**Re: Modification Request to Plans Approved by the Zoning Commission
Z.C. Order Nos. 06-46B-E
Square 701, Lots 857, 858, 859**

This letter is submitted on behalf of Half Street Residential PJV LLC (the “Applicant”) to request approval of a minor modification to plans previously approved by the Zoning Commission of the District of Columbia (the “Commission”) for property located at Square 701, Lots 857, 858, and 859 (the “Property”). This request is submitted pursuant to Subtitle A §§ 304.5 and 304.6 of the 2016 Zoning Regulations (“ZR16”). A signed copy of the form requesting the modification is attached hereto as Exhibit A. Relevant portions of the plans approved by the Commission and other supporting documentation are attached hereto as Exhibits B - F.

Preliminary plans for the Tenants are attached as Exhibit F. In order to accommodate both retailers, the Applicant proposes to construct a mezzanine space toward the rear of the subject retail space. The mezzanine would measure approximately 1,135 GFA, and would contain a kitchen, a freezer and cooler, and an equipment platform. As noted above, based upon the DCRA Zoning Data Summary the Project contains approximately 462,710 GF

Previously Approved & Proposed Floor Plan - Level 1

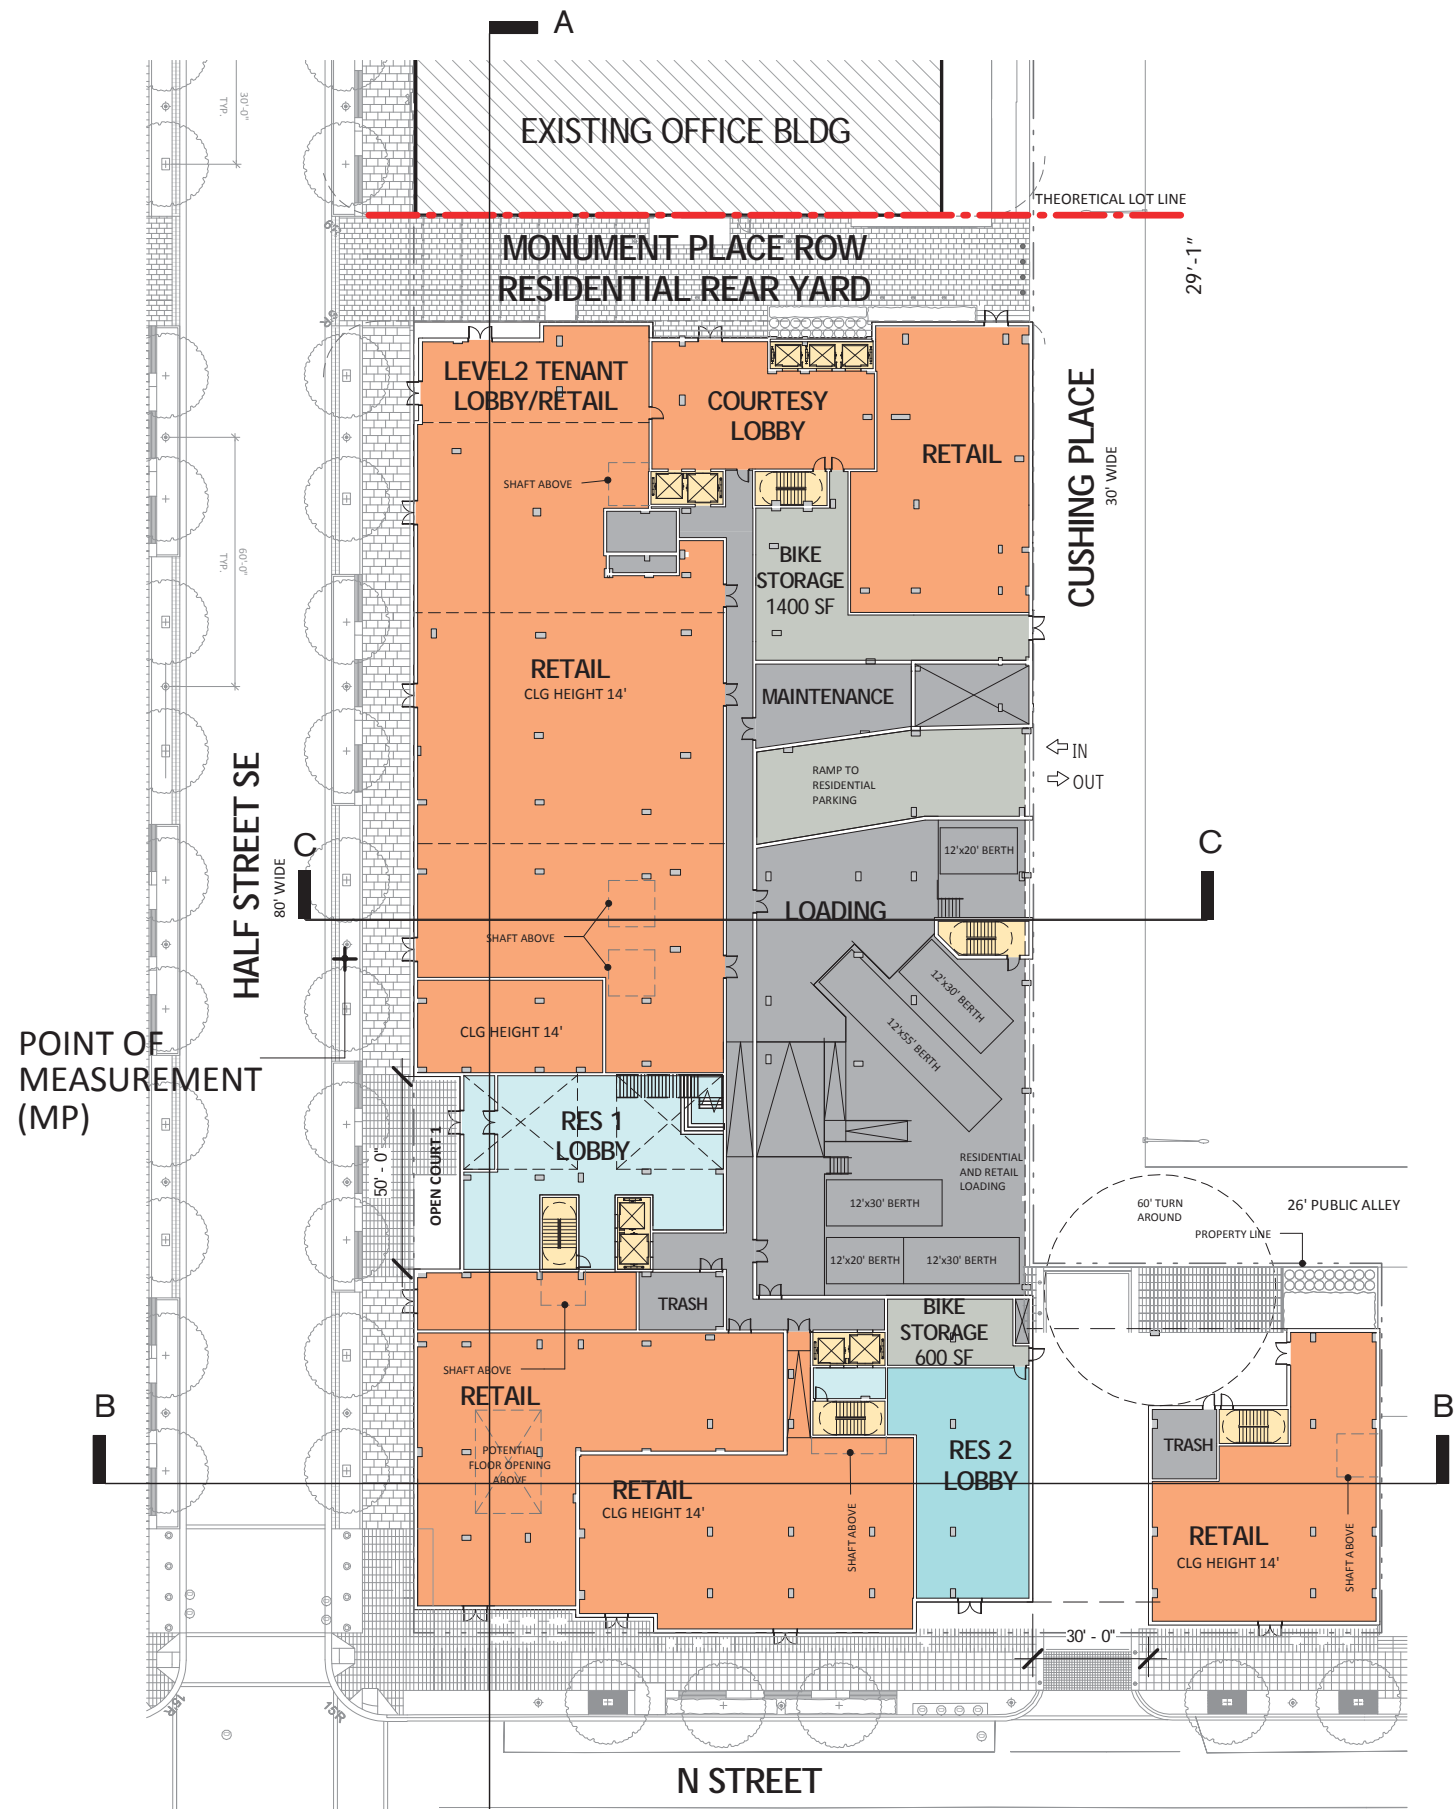
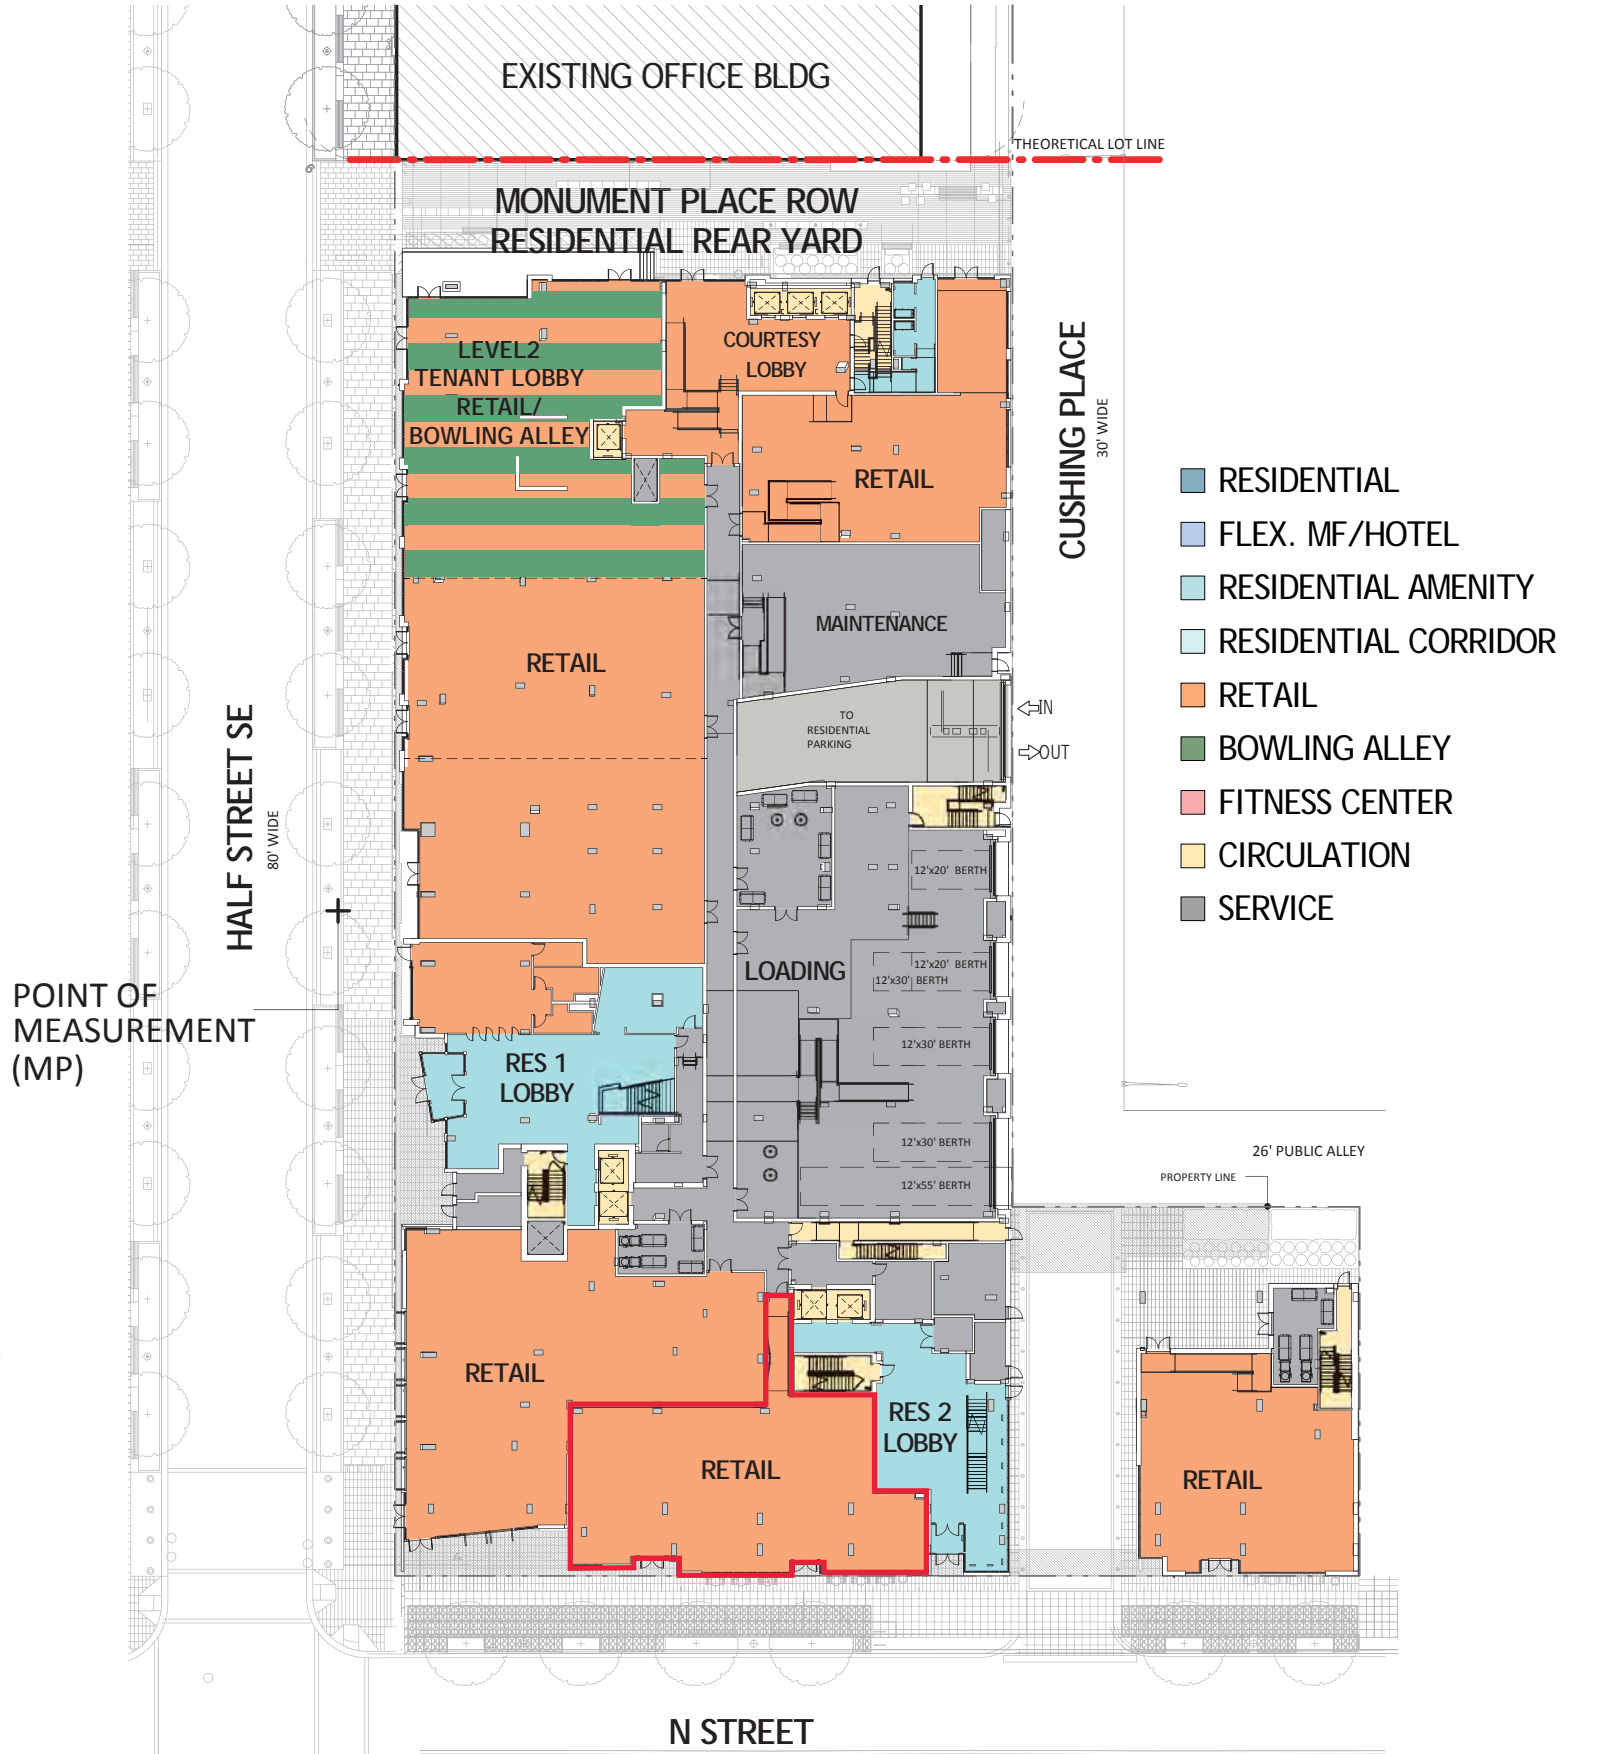
As shown on the approved Level 1 plan included in Exhibit C, the Property is “L” shaped with the portion along N Street, SE being much narrower than the portion along Half Street, SE, which is a designated street under the CG zone regulations that is subject to certain preferred use and design requirements. One such design requirement is for the ground floor along Half Street, SE to have a clear ceiling height of 14 feet to a depth of 36

feet (*See* 11-K DCMR § 510.1(c)(2)). As a result of this requirement, the back of house functions of the retail space along Half Street, SE are pushed deeper into the Project which limits the depth of the already shallow retail space along N Street particularly the retail space in question. Furthermore, the north side of the Project contains retail uses along Monument Place, an active pedestrian promenade that connects Half Street, SE to Cushing Place, SE, which pushes the loading facilities southward thereby further constraining the depth of the retail space along N Street.

B. SOUTH ELEVATION *Previously approved*

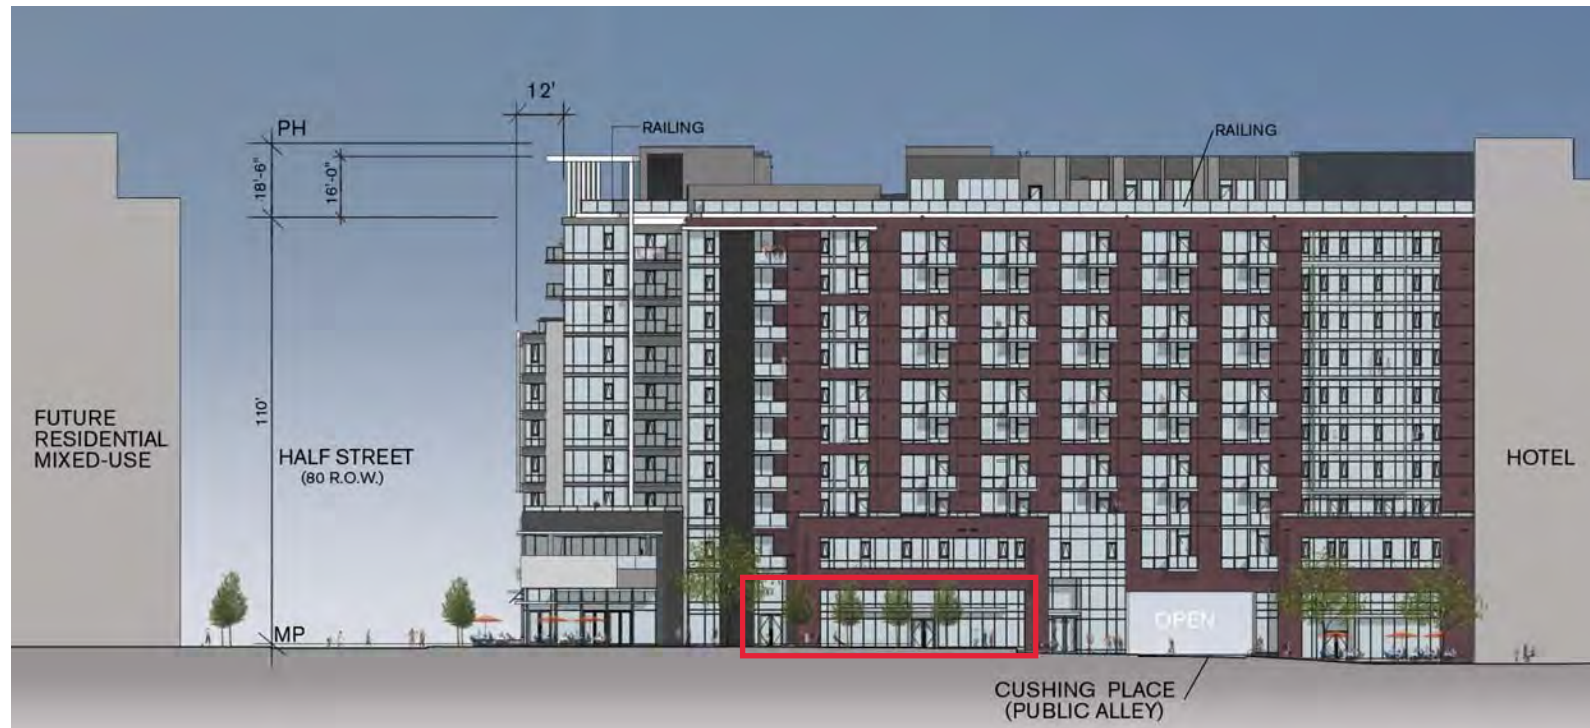
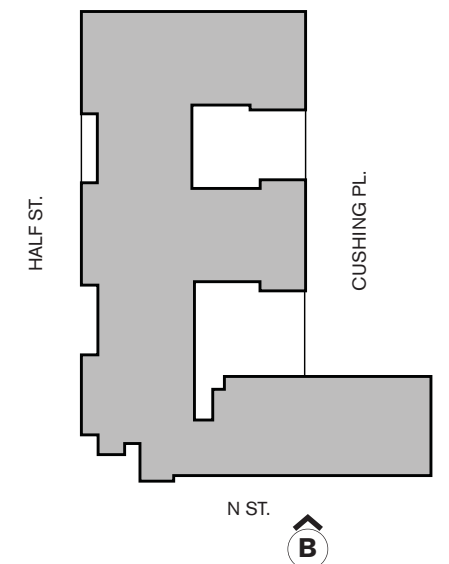
¹ The drawings included in Exhibit C are a subset of the modifications plans approved by the Commission pursuant to Z.C. Order No. 06-46D. The drawings show a comparison of the previously approved plans and the modified plans submitted in that case. The current approved Level 1 plan is shown on the right side of Exhibit C, Sheet A1, and the current approved south elevation is shown on the bottom of Exhibit C, Sheet A5.

The requested minor modification does not propose to relocate any building or building wall. Further, as demonstrated by comparing the elevations contained in Exhibits C and F, the proposed mezzanine will not require any changes to the exterior façade of the building as it is currently approved by the Commission.

1 EXTERIOR ELEVATION - SOUTH
1/4" = 1'-0"

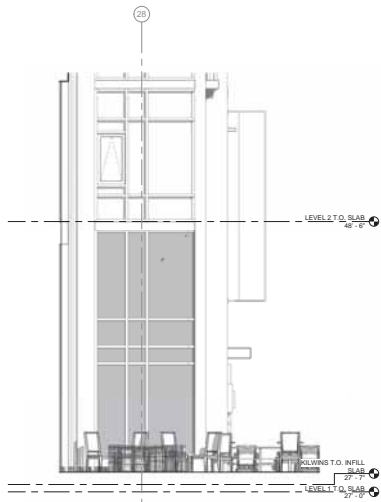
As shown on the plans attached as Exhibit F, the proposed mezzanine will not require any changes to the exterior south façade of the Project, as it is currently approved by the Commission. In addition, the mezzanine will not have any impact on the quality of the retail space. Specifically, the distance from the front glass line of the retail space to the outer face of the mezzanine is approximately 22 feet, within which the clear ceiling height will be approximately 20 feet. Indeed, the only impacts caused by the proposed mezzanine will be positive. Directly across N Street from the Project is the Nationals Park parking garage and ticket window. Thus, the successful activation of the pedestrian realm along N Street falls solely to the north side of the street. The proposed minor modification will facilitate this activation by helping to maximizing the number of retail tenants that are able to occupy the subject retail space.
